Euston Tower

Independent review of pre-planning Feasibility Study (Volumes 1-3)

Project number	2230145
Project name	Euston Tower
Client	London Borough of Camden
Status	For information
Revision	P8
Date	03-03-2025

Figure 1: Modernising options 1, 2, 3a and 3b (Volume One, page 146 to 149)

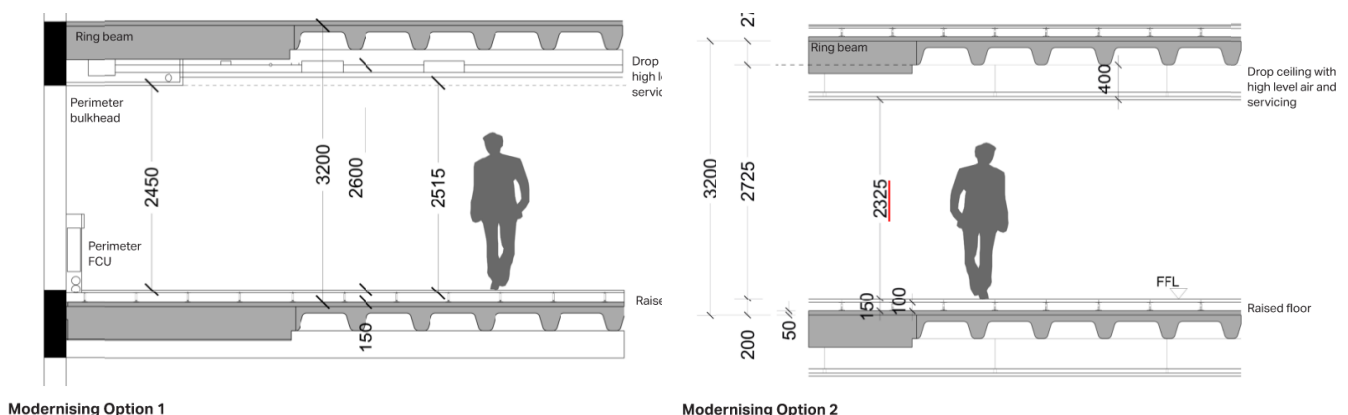
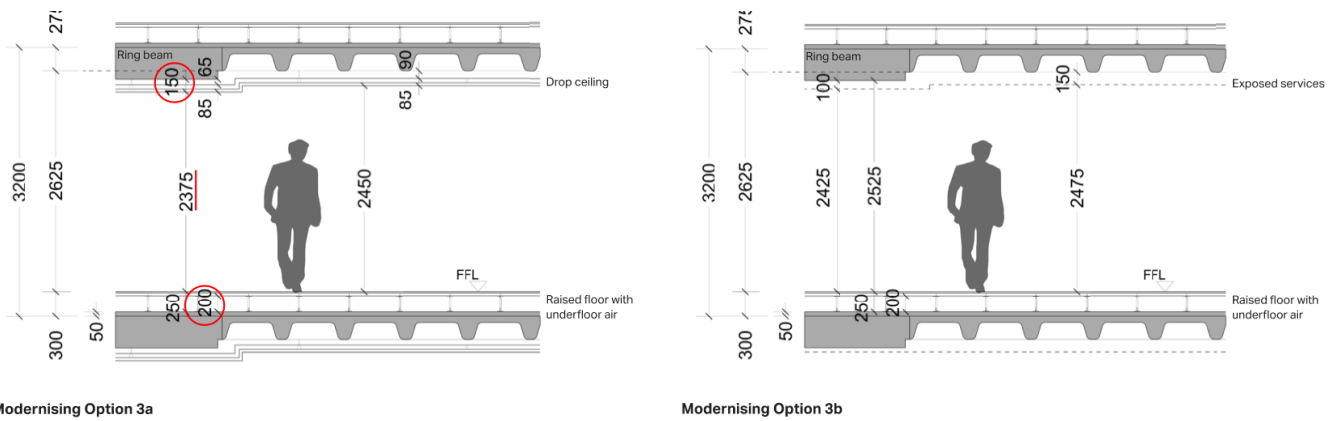
Volume One includes four options for upgrading the building to provide modern services (Figure 1, below). Scaled section drawings showing slab depths and floor-to-ceiling dimensions have been provided. BCO guidance sets a minimum floor-to-ceiling height for refurbishments of 2.45m.

When discussing the floor-to-ceiling heights of the existing building the Feasibility Study states that 'without a ceiling ... significant areas would be compromised and/or no compliant'³⁰. As noted elsewhere in this report we do not agree with the use of the term 'compromised' as this is subjective. Quality depends on multiple factors not solely floor-to-ceiling heights. Furthermore, as shown in Figure 14.3³¹ of the study the 'compromised' area of floorplate is around the perimeter of the building, where floor-to-ceiling heights are impacted by the downstand beam. We do not feel that it is reasonable to claim that this is a 'significant' area.

Figure 2: Extract from Volume Three pages 98-99

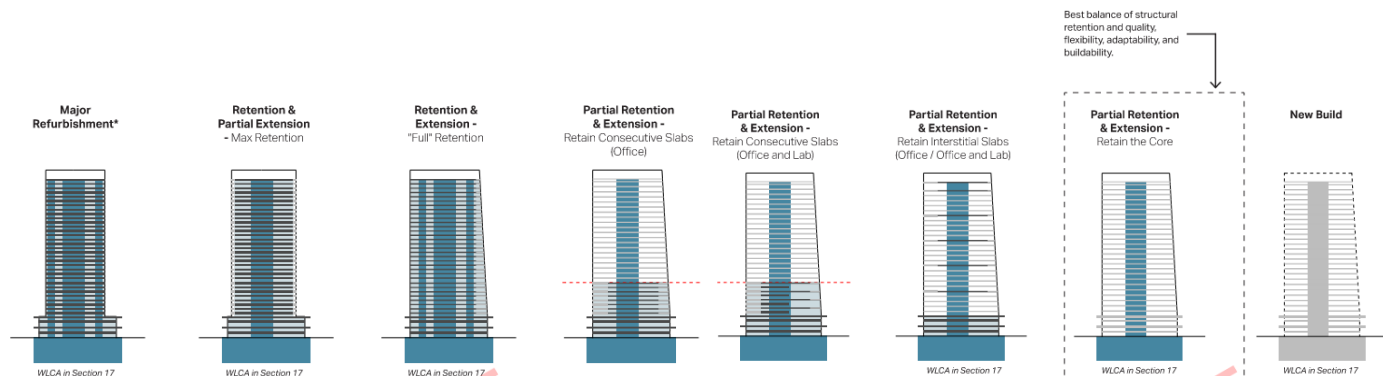
Table 1 compares the development options considered by the Applicant Team against the four options listed in the CPG. These are also shown in Figure 2. The level of intervention required for each option is summarised in figure 17.1 of Volume Three³⁹. The Applicant Team has utilised five factors for assessing each development option⁴⁰:

There is, however, no clarification provided on how each of these points are weighted with regards to the assessment of each development option. In particular there is a question around replacing a large percentage of an existing building to provide a more 'future proofed' or adaptable space. This is discussed in more detail below when reviewing the 'max retention' and 'full retention' options below.
